# UNITED STATES PATENT AND TRADEMARK OFFICE

10/568,170

<b>Office Action Summary</b>	<b>Application No.</b> 10/568,170	<b>Applicant(s)</b> STAMPS ET AL.
	<b>Examiner</b> Melody M. Burch	<b>Art Unit</b> 3657

**DETAILED ACTION**

**Fig. 4**

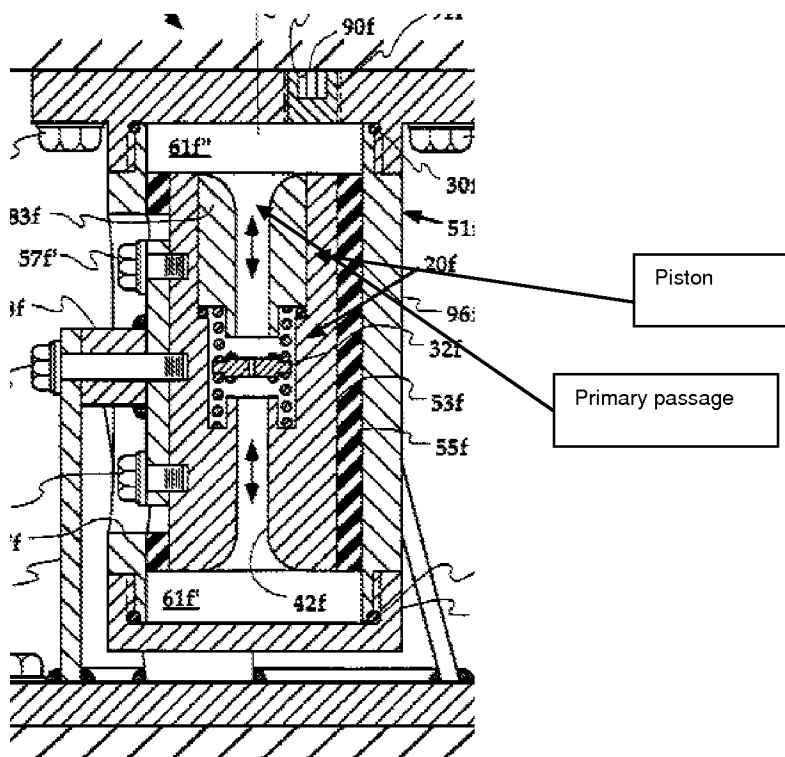
Re: claim 20. Jones et al. show a damper having an adjustable spring rate, comprising: a piston as labeled having an axis, an outer surface, and opposing ends; a housing 51f; at least one elastomeric seal 55f in sealing contact with the outer surface of the piston, the at least one seal being coaxial with the piston and limiting movement of the piston to a path along the axis of the piston, the at least one seal also defining fluid chambers 61f' and 61f' adjacent the ends of the piston, the at least one seal also being fixed to the housing; a primary passage 42f extending through the piston from one end to the opposing end of the piston, the primary passage providing fluid passage between the fluid chambers; and a selectively switchable valve 20f using the 1b embodiment disposed within the piston and in fluid communication with the fluid passing through the primary passage, the selectively switchable valve being adapted for controlling a flow of fluid from one of the chambers to another of the chambers through the primary passage, such that when the selectively switchable valve is open, the flow

of fluid through the primary passage is not resisted by the selectively switchable valve in either direction; further, when the selectively switchable valve is closed, the flow of fluid through the primary passage is restricted in both directions by the selectively switchable valve; and wherein when the flow of fluid through the primary passage is permitted, movement of the piston is resisted by a first spring rate due to a shear force required to cause shear deflection of the seals; and when the flow of fluid through the primary passage is restricted, movement of the piston is resisted by a second spring rate due to a fluid force required to cause bulging deflection of the seals.

See annotated figure 4 below.

Jones et al. are silent with regards to the at least one seal being a plurality of seals. In *In re Harza*, 274 F.2d 669, 124 USPQ 378 (CCPA 1960) the court held that mere duplication of parts has no patentable significance unless a new and unexpected result is produced.

Re: claim 11. Jones et al. show a damper having an adjustable spring rate, comprising: a piston as labeled having an axis, an outer surface, and opposing ends; a housing 51f; at least one elastomeric seal 55f in sealing contact with the outer surface of the piston, the at least one seal being coaxial with the piston and limiting movement of the piston to a path along the axis of the piston, the at least one seal also defining fluid chambers 61f' and 61f' adjacent the ends of the piston, the at least one seal also being fixed to the housing; a primary passage 42f extending through the piston from one end to the opposing end of the piston, the primary passage providing fluid passage between the fluid chambers; and a selectively switchable valve 20f using the 1b embodiment disposed within the piston and in fluid communication with the fluid passing through the primary passage, the selectively switchable valve being adapted for controlling a flow of fluid from one of the chambers to another of the chambers through the primary passage, such that when the selectively switchable valve is open, the flow of fluid through the primary passage is not resisted by the selectively switchable valve in either direction; further, when the selectively switchable valve is closed, the flow of fluid through the primary passage is restricted in both directions by the selectively switchable valve; and wherein when the flow of fluid through the primary passage is permitted, movement of the piston is resisted by a first spring rate due to a shear force required to cause shear deflection of the seals; and when the flow of fluid through the primary

passage is restricted, movement of the piston is resisted by a second spring rate due to a fluid force required to cause bulging deflection of the seals.

See annotated figure 4 above.
